# **Falcon Highlands South**

## **Preliminary Drainage Report**

**April 26, 2023**

**PUDSP-22-005**

DR. SLP	CH. RDL
P.M. RDL	
JOB: 21002568	
SHEET NO. 1	
DR-02

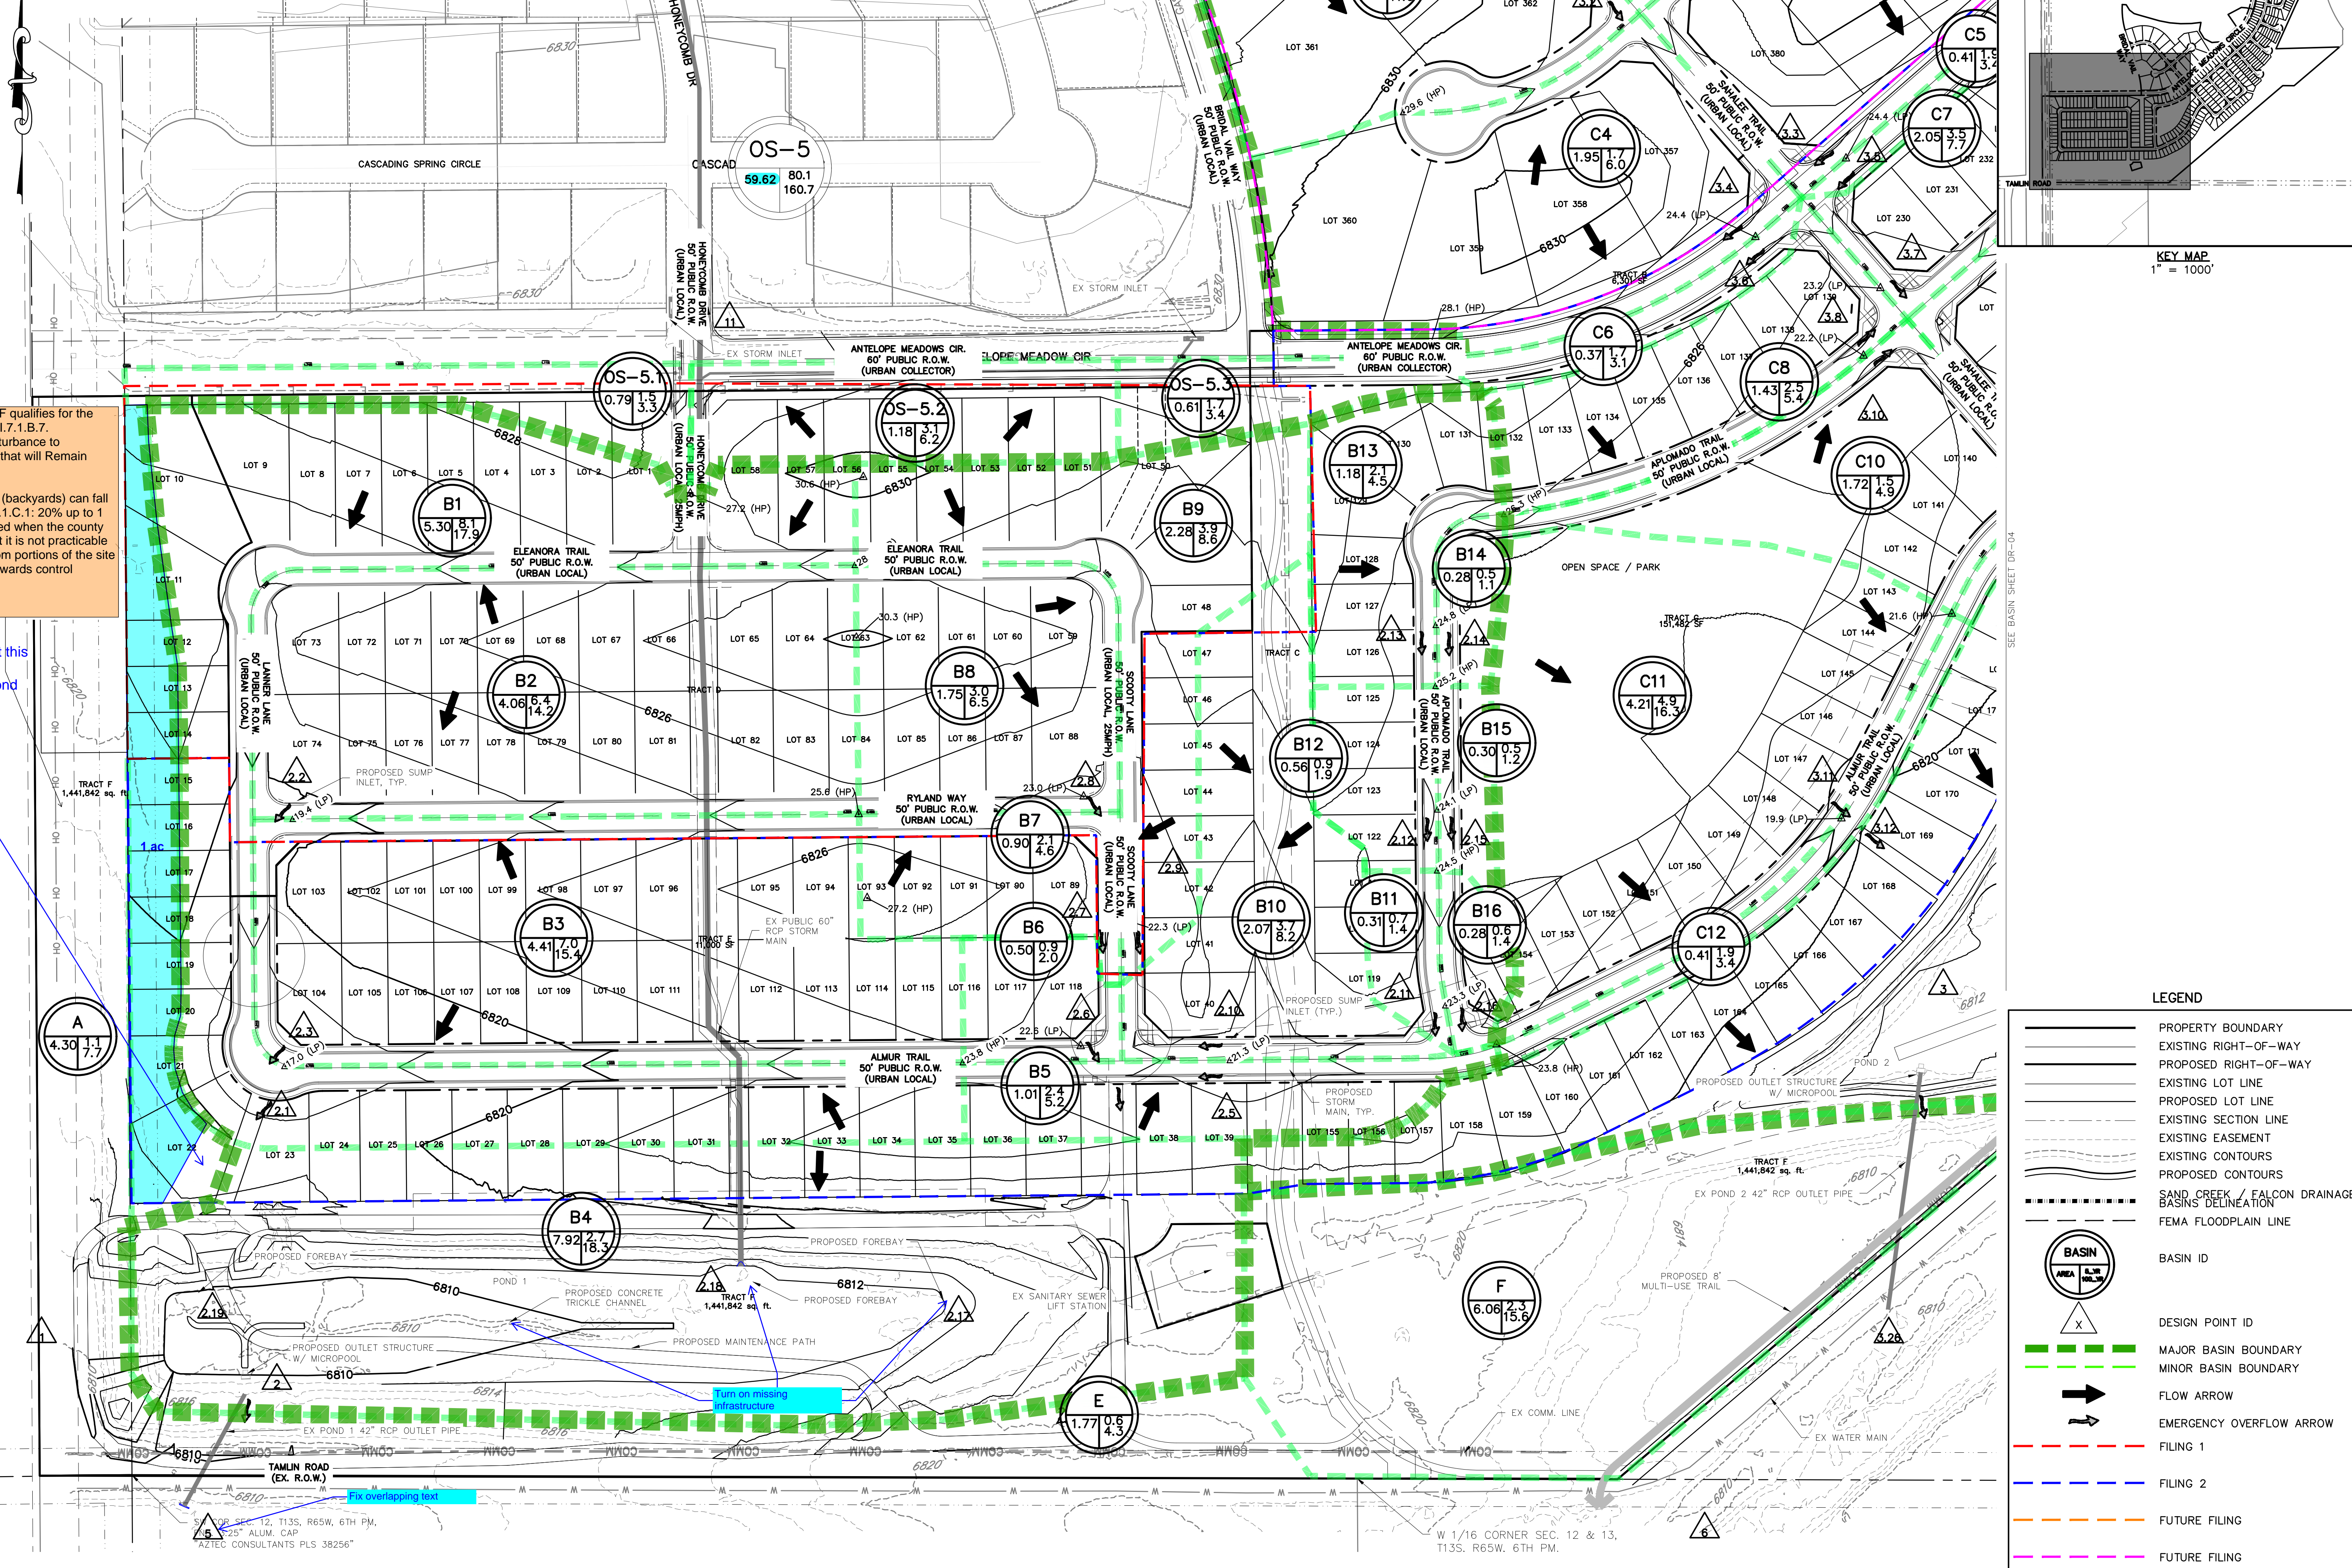
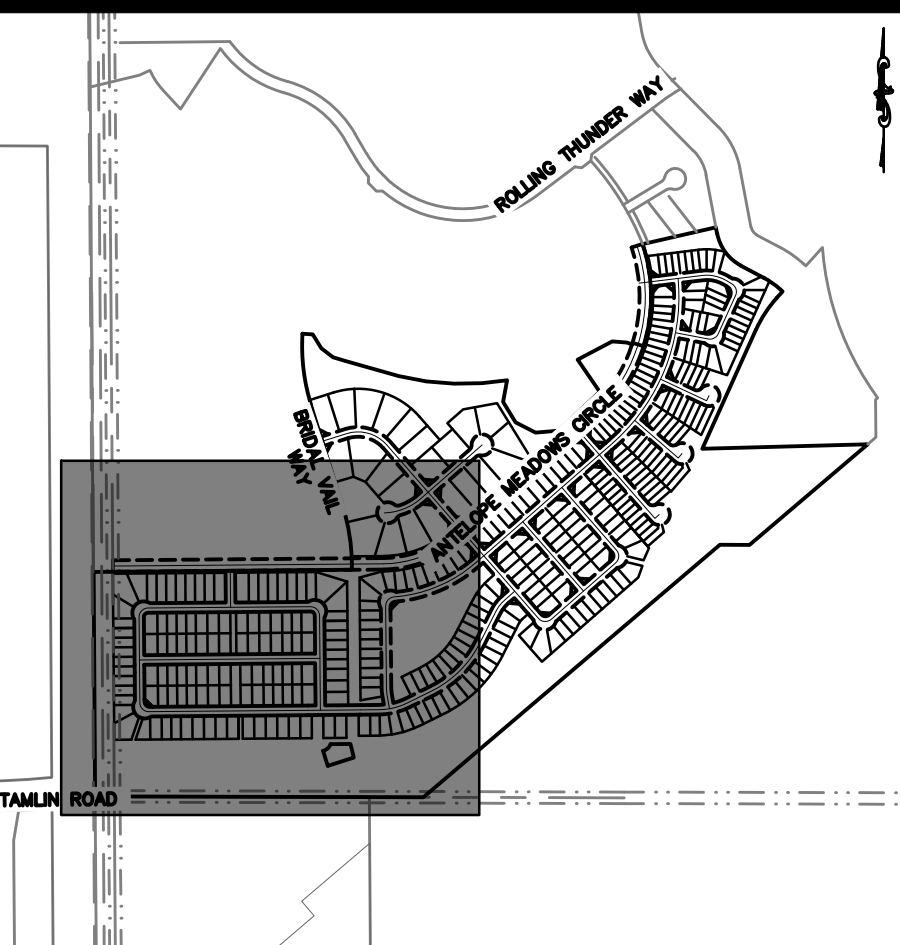
It appears that this area needs to drain to the pond to meet the exclusion requirements

JOB: 21002568  
SHEET NO. 1  
DR-04

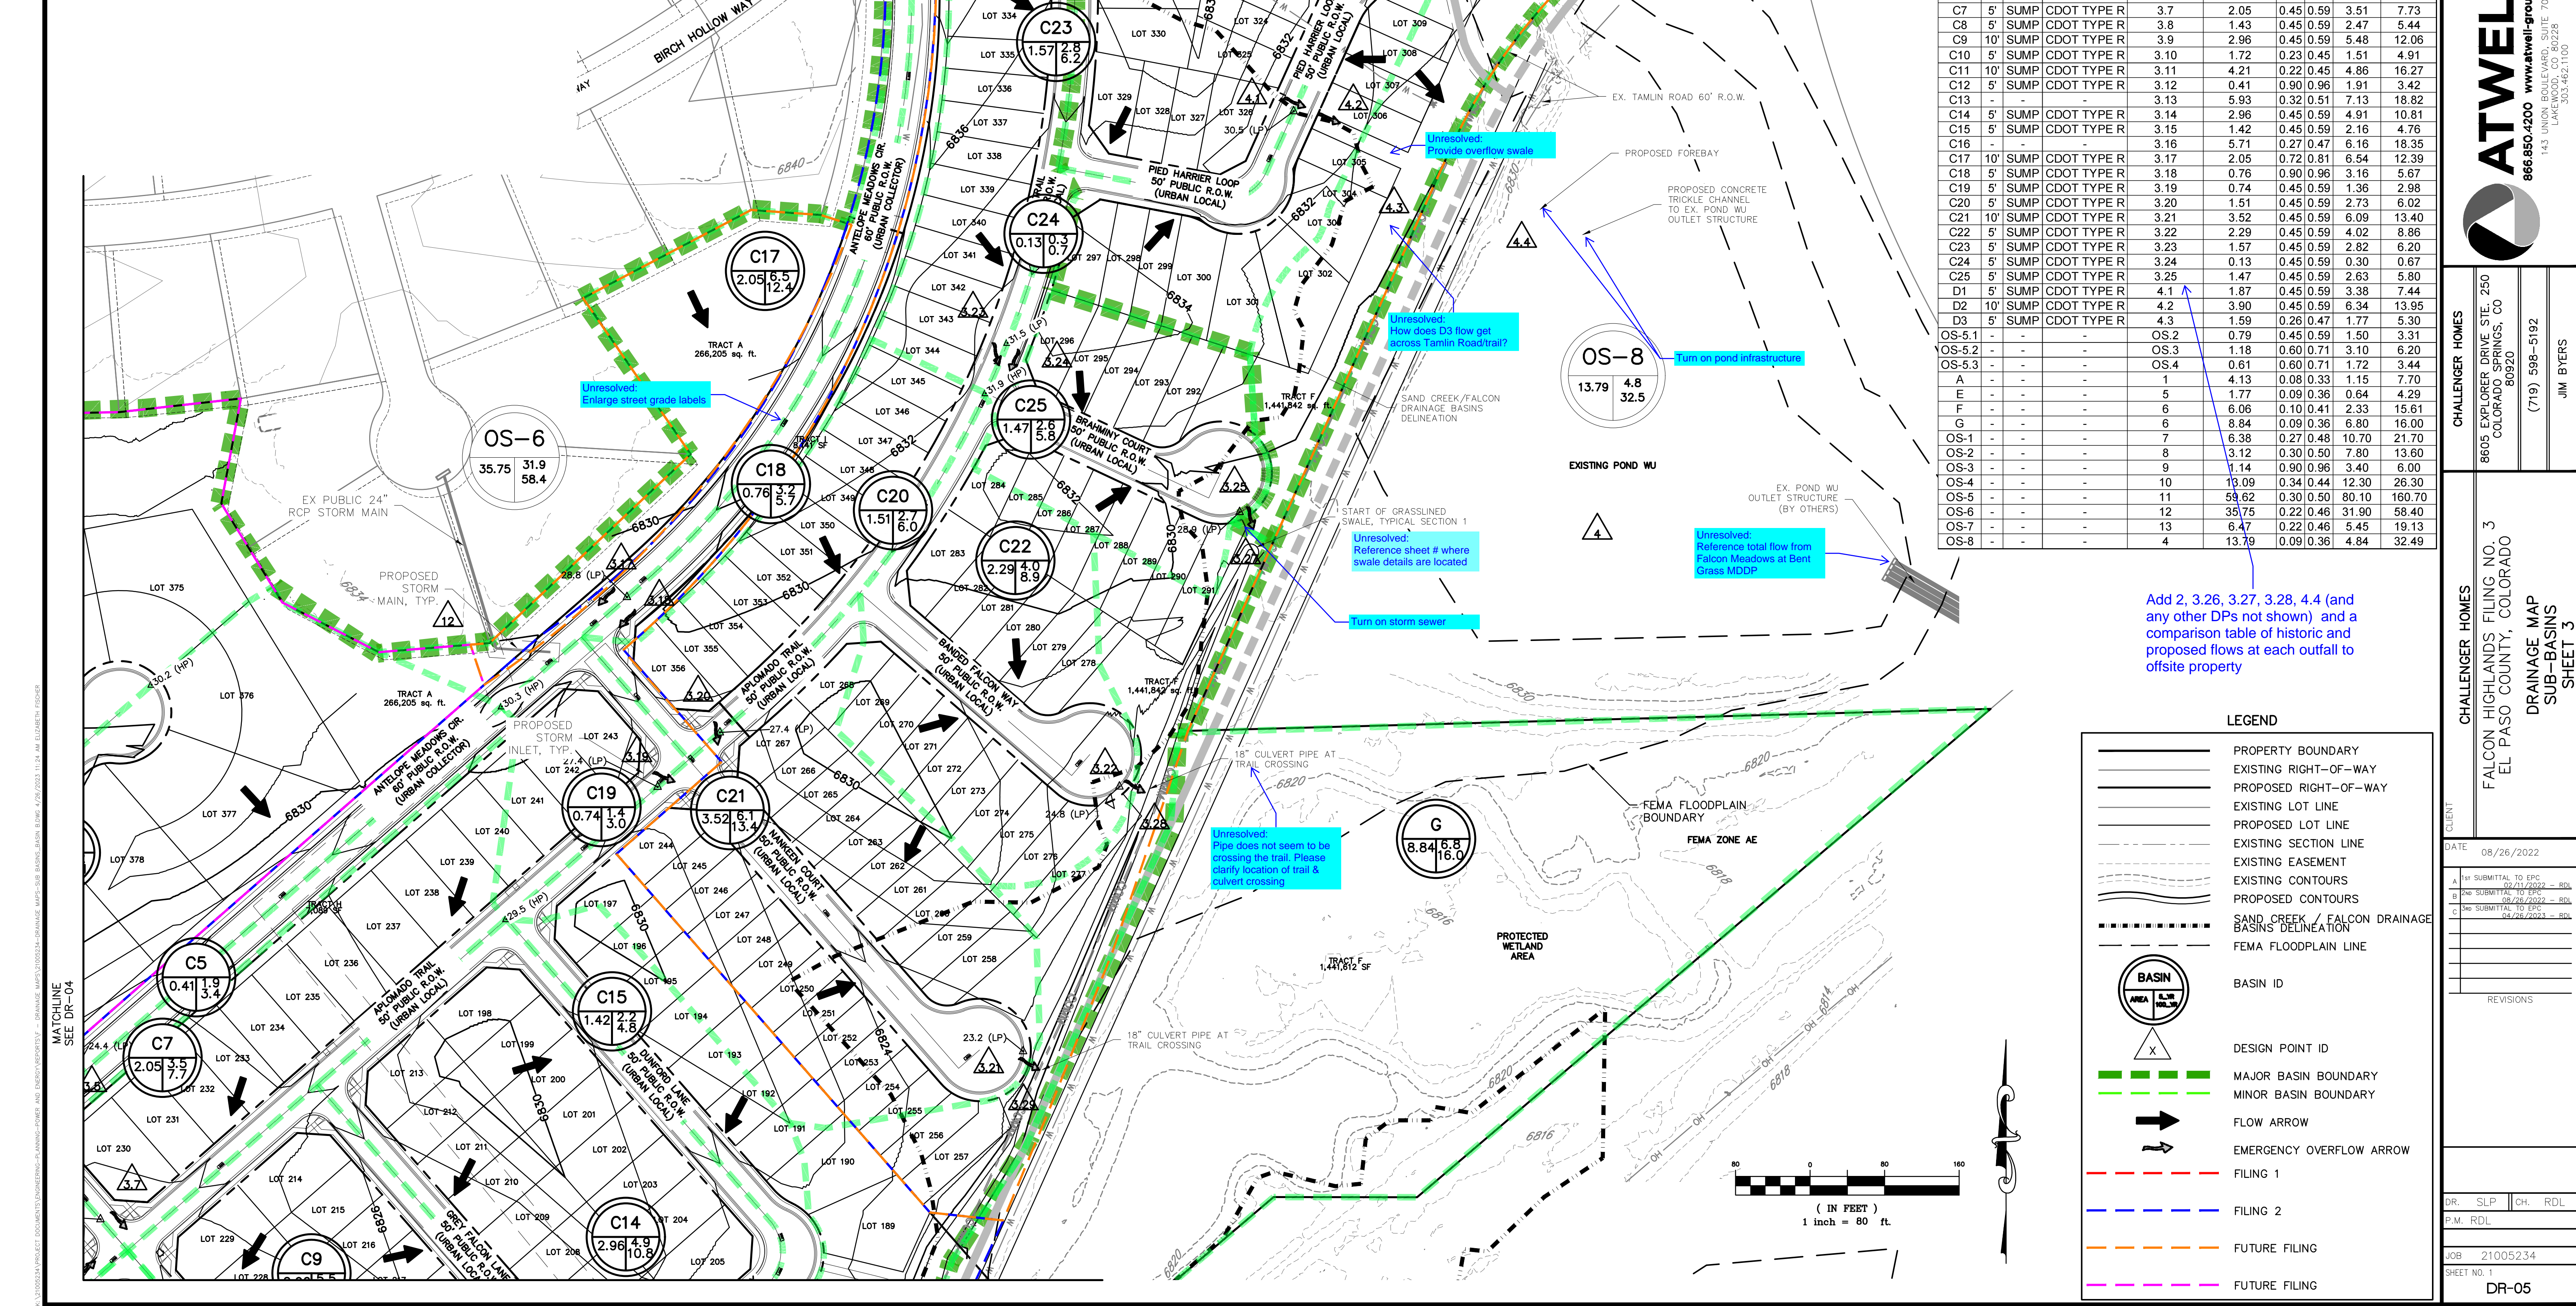
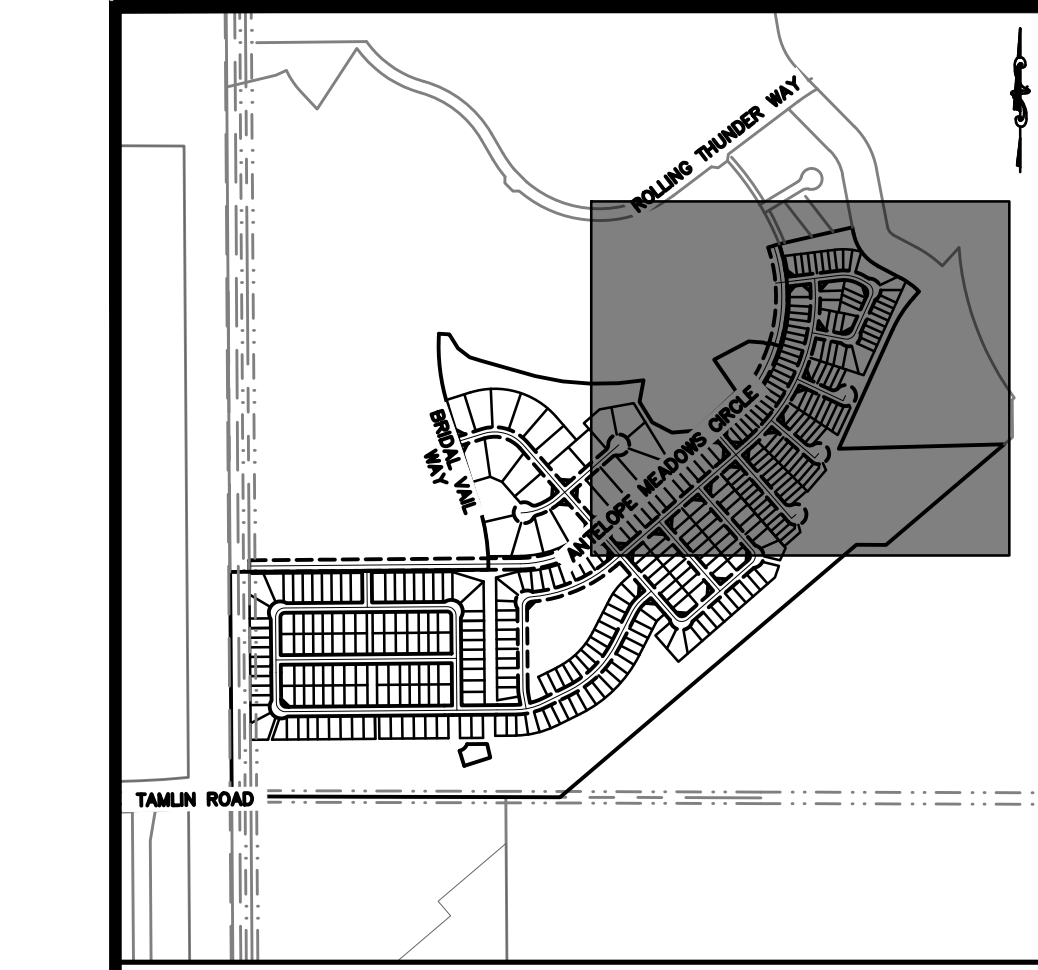
Add 2, 3.26, 3.27, 3.28, 4.4 (and any other DP's not shown) and a comparison table of historic and proposed flows at each outfall to offsite property

Replace water quality map
